PUBLIC INTEREST REVIEW FOR GROUND WATER APPLICATIONS

SUBJECT: Application G- 16334 Supersedes review of N/A
Date of Review(s)

A. **GENERAL INFORMATION:** Applicant's Name: Monte B. and Jan D. Wasson County: Wasco

A1. Applicant(s) seek(s) 0.13 cfs from one well(s) in the Hood Basin,
Eightmile Creek subbasin Quad Map: Dufur West

Wells in the vicinity of application G 16334

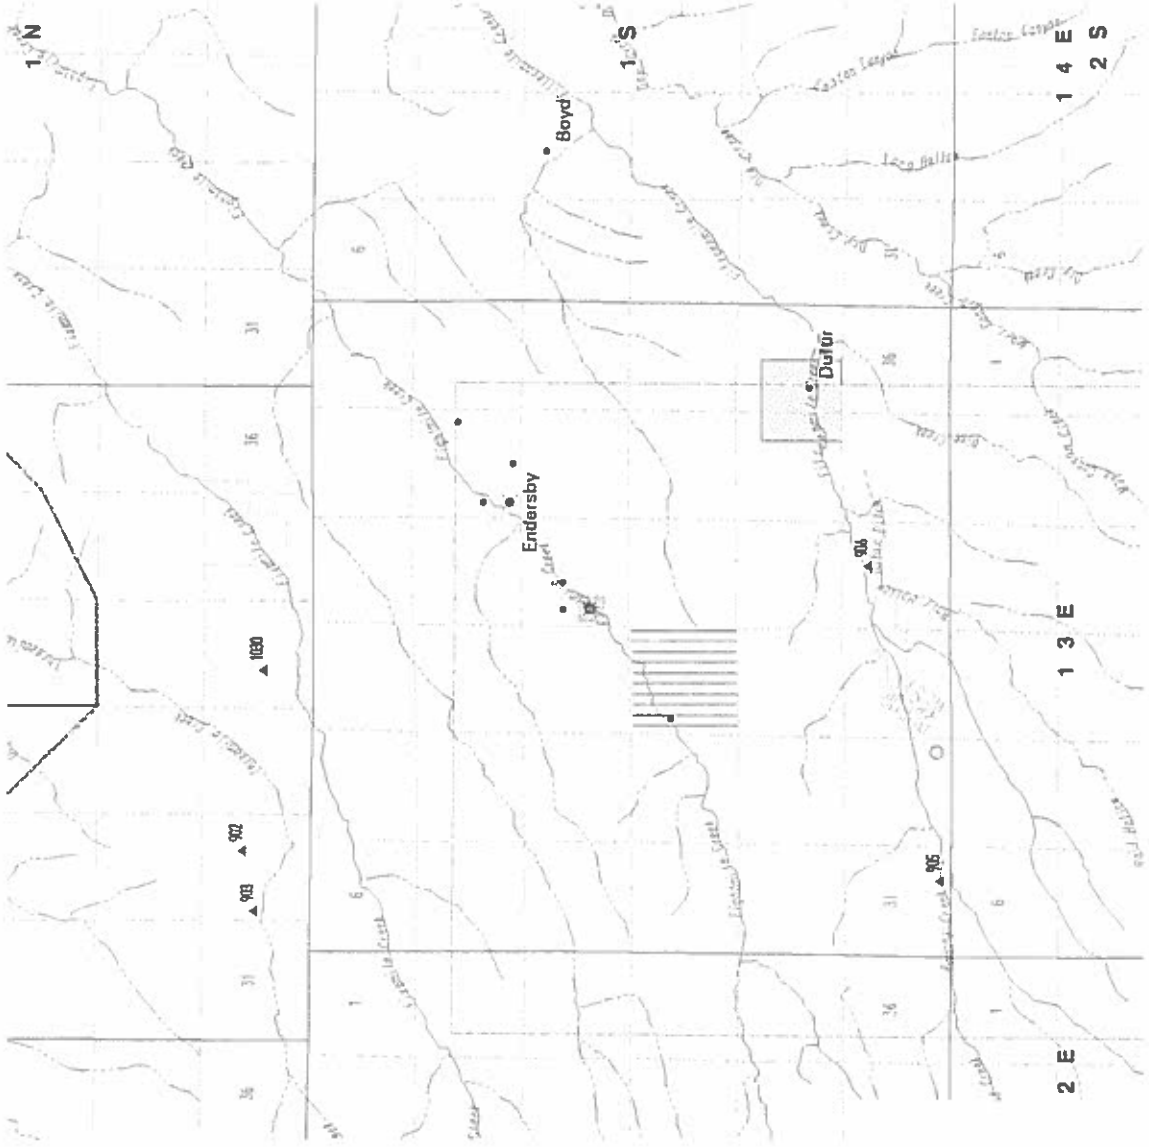
Basis for aquifer hydraulic connection evaluation: Locally, both the head in the well and the depth to the water-bearing zone are below the level of Eightmile Creek. Hydraulic connection is very likely at some downstream reach, but the distance is uncertain where this is occurs.

Basis for impact evaluation: This section likely applies. However, the distance where hydraulic connection is likely to occur downstream on Eightmile Creek is not known with any certainty. It may range from about one mile to over two miles. Therefore, I believe that it is not appropriate to attempt calculation of interference on this basis.
